GR-2 Public Health

Responses to Comments

Figure GR-2-A. Comparison of the County’s noise significance guidance with Knopper best practice, plotted as hourly L_{eq} values versus consecutive hours of a typical day/night cycle

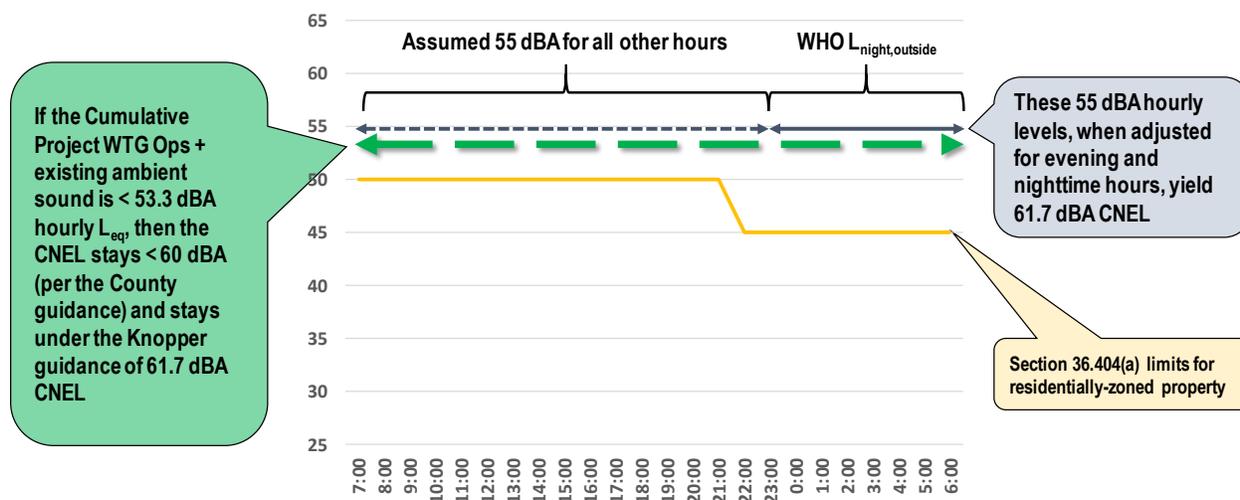
Comments received relating to noise annoyance and health effect concerns can generally be split into four categories: (1) A-weighted sound levels, which refer to audible community noise and for which the County assesses annoyance vis-à-vis Section 36.404 et al. from its Noise Ordinance; (2) low-frequency noise, which can be audible and resides in the 20 hertz (Hz) to 200 Hz range of the sound spectrum; (3) infrasound, which is considered inaudible to human hearing; and (4) amplitude modulation.

Figure GR-2-A shows how the Knopper best practice “for wind turbine development in the context of human health” at 55 dBA compares with the County’s lower 53.3 dBA level associated with the County’s 60 dBA CNEL threshold. The dark blue solid line shows 55 dBA L_{eq} values representing eight consecutive hours of operations, with the dashed blue line showing the extrapolation for other hours.

The thicker dashed green line at 53.3 dBA in Figure GR-2-A shows the constant hourly L_{eq} that must be met to comply with the County’s 60 dBA CNEL value. Because the County’s CNEL threshold of 60 is lower than the WHO guidance, the County concludes that its noise significance standard is adequately protecting human health. This is also true for the hourly L_{eq} thresholds prescribed by Section 36.404(a) of the County’s Noise Ordinance for single-family residential properties, represented by the gold line in Figure MR-4-G, reflecting 50 dBA hourly L_{eq} during the day and 45 dBA hourly L_{eq} at night. These thresholds are also below the WHO guidance.

In summary, projects that meet the County’s 60 CNEL standard can be reasonably assumed to be protective of human health. Nonetheless, if noise exceeds the levels shown by the gold line in Figure GR-2-A, nearby residents could still be annoyed. If a project’s operational noise levels exceed the County’s hourly L_{eq} standards and/or the 20 dB difference between predicted C-weighted wind turbine generator operation noise and the A-weighted Residual Background Sound Criterion, potential annoyance could result.

Figure GR-2-B. Comparison of A, C, and G-weighting decibel (dB) adjustment curves below 100 Hz

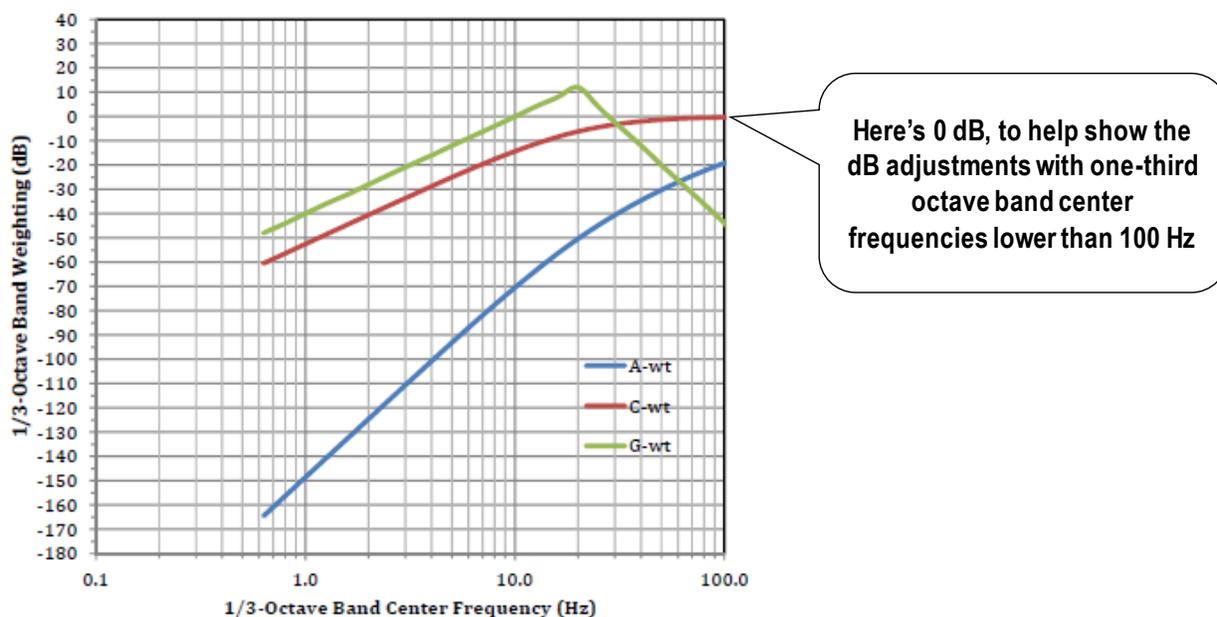
Both the February 28, 2014 and March 18, 2019 Wilson-Ihrig reports also discuss research that they claim “seem[s] to provide strong evidence of a cause and effect relationship” between infrasound and low-frequency noise and eventual adverse human health responses. In particular, and although infrasound is below the range of human hearing, the Wilson Ihrig reports refer to stimulation of the outer hair cells of the auditory portion of the ear (cochlea) at very low frequencies. Specifically, the Wilson-Ihrig reports quote a Salt and Kaltenbach study that 60 dBG “will stimulate the OHC [outer hair cells] of the human ear.” The “dBG” descriptor here means that the sound level referred to by Salt and Kaltenbach is G-weighted, which is different from an unweighted dB level or an A-weighted or C-weighted value. Figure GR-2-B, appearing in both of the Wilson-Ihrig reports (i.e., from page 25 of

the March 18, 2019, report, and page 29 of the February 28, 2014, report) graphically displays the difference in these three sound level weighting scales.

The three sound level weighting curves shown in Figure GR-2-B are decibel value adjustments applied to an unweighted sound level. The A-weighting curve, shown in blue, mimics the typical sensitivity of average healthy human hearing and therefore emphasizes sound in the usual speech range of audible sound frequencies (500 Hz to 4,000 Hz) not displayed in Figure GR-2-B. Average healthy human hearing is less sensitive with decreasing frequency, and the blue A-weighting curve reflects this by showing dB adjustments of approximately -20 at 100 Hz and -50 at 20 Hz, the latter of which is the understood limit of audible sound.

The C-weighting curve, shown in red on Figure GR-2-B, applies lesser decibel discounts with decreasing frequency; for instance, the discount is less than 10 dB at the lowest end of the audible spectrum (20 Hz) and hence a much smaller dB adjustment than the A-weighting curve would apply at this same sound frequency. For this reason, the C-weighting curve is often applied in the music industry to assess sound that has audible low-frequency content (bass frequencies) and for which A-weighting would not be appropriate. The G-weighting curve, shown in green in Figure GR-2-B, has an angular shape. G-weighting is used to evaluate inaudible sound below 20 Hz.

notes that the Wilson-Ihrig reported measurements at the representative residences are unweighted and, when adjusted to the G-weighting curve, do not exceed the G-weighted sound level of 60 dBG. Specifically, as illustrated in Figure GR-2-B, the G-weighting adjustment at 1 Hz is approximately -40 dB, which when applied to an unweighted level of 63 dB at 1 Hz would convert it to 23 dBG. A measurement of 23 dBG is substantially lower than 60 dBG.

Figure GR-2-C. Contrast of unweighted sound pressure level and G-weighted sound pressure level plots for Skains residence

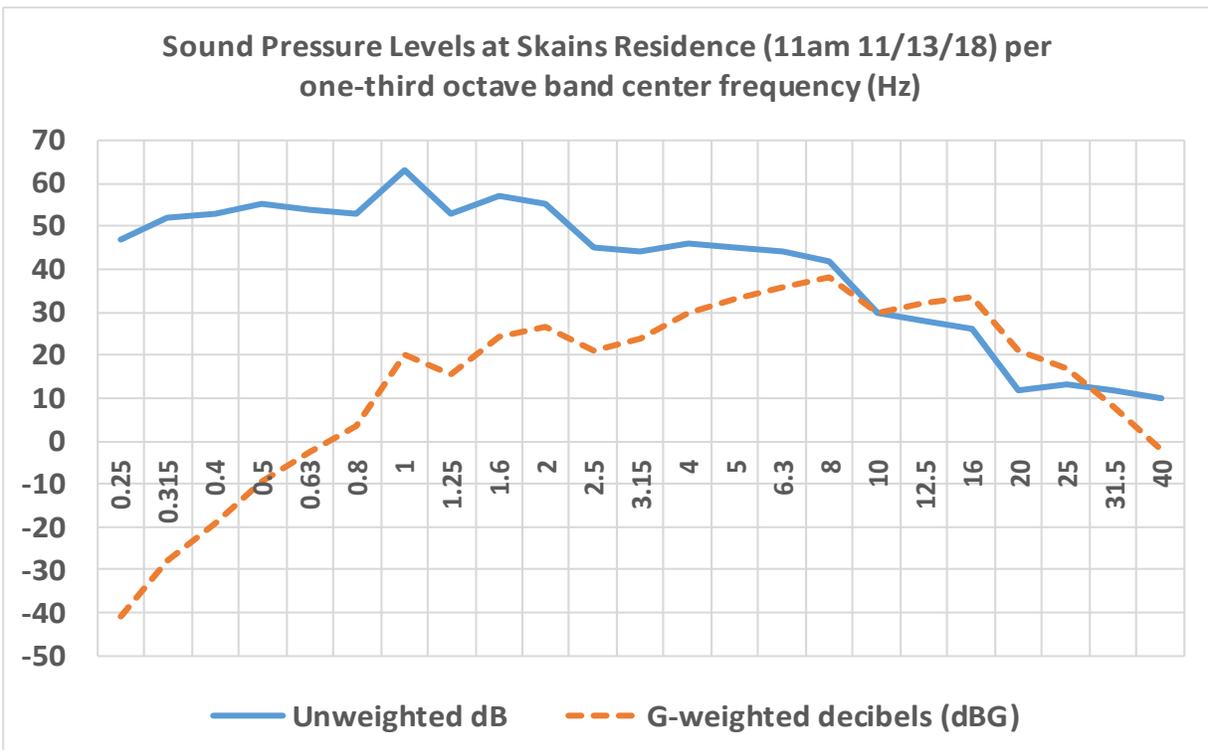
Comments were received on the Draft EIR expressing concerns regarding the potential adverse health effects of infrasound and low-frequency noise impacts from the wind turbines. Several comments refer to the March 18, 2019, Wilson-Ihrig noise report that was prepared for Backcountry Against Dumps and is included as an attachment to Comment Letter O5. The 2019 Wilson-Ihrig noise report includes a prior February 28, 2014 Wilson-Ihrig report as an appendix. The report documents noise recordings in the Jacumba and Boulevard areas. The report states the intent of the recordings was to document existing infrasound and low-frequency noise (ILFN)²³ generated by existing wind turbines in the area, to document C-weighted noise levels in the vicinity of the Project’s proposed wind turbines, and to suggest that there are adverse health consequences from such exposure. The report presents measurements of unweighted infrasound levels at a number of residential properties in the Project vicinity. These studies state that infrasound and low-frequency noise from existing operating wind turbines up to many miles away are measurable at these residences and further suggest that exposure to infrasound and low-frequency noise could result in adverse health impacts.

Figure GR-2-C below illustrates the application of G-weighting decibel adjustments to a sample of Wilson Ihrig’s noise data. Please refer to Figure C-4 of the Wilson-Ihrig March 14, 2019, report for the noise data. The solid blue plot across the 0 to 40 Hz frequency range represents the unweighted sound pressure level (dB) measured by Wilson-Ihrig at the Skains residence (described to be “1.65 miles from nearest WT [wind turbine],” with the 63 dB peak at 1 Hz described as due to Ocotillo Wind Turbine operation at a distance of 11 miles) on November 13, 2018. The dashed orange plot shows Wilson Ihrig’s unweighted values after adjusting for the G-weighted scale. When the G-weighting dB adjustment is made, the dBG values displayed by the dotted orange line in Figure GR-2-C are well below 60 dBG. As such, stimulation of the human ear outer hair cells would not occur. Therefore, the “potentially numerous consequences” suggested to occur by the 2011 Salt and Kaltenbach study at values above 60 dBG would not be occurring in the Project Vicinity, where the existing measurements are below 60 dBG.

The above analysis applies not just to the Skains residence but also to all of the other sample measurements in the Wilson Ihrig and dBF reports. After application of G-weighting adjustments to the 13 unweighted noise level measurements from the December 16, 2019, dBF report, the 20 unweighted noise measurements from the Wilson-Ihrig 2014 report, and the 16 unweighted noise measurements from the Wilson-Ihrig 2019 report, it is apparent that the G-weighted threshold of 60 dBG is not exceeded at any of their surveyed locations.

In summary, the concerns raised by Wilson-Ihrig about potential direct health effects due to infrasound exposure from operating wind turbines include association with exceedance of the 60 dBG threshold. The anticipated infrasound from the Project's proposed wind turbines is not expected to exceed a G-weighted value of 60 and thus is not expected to cause direct health impacts.
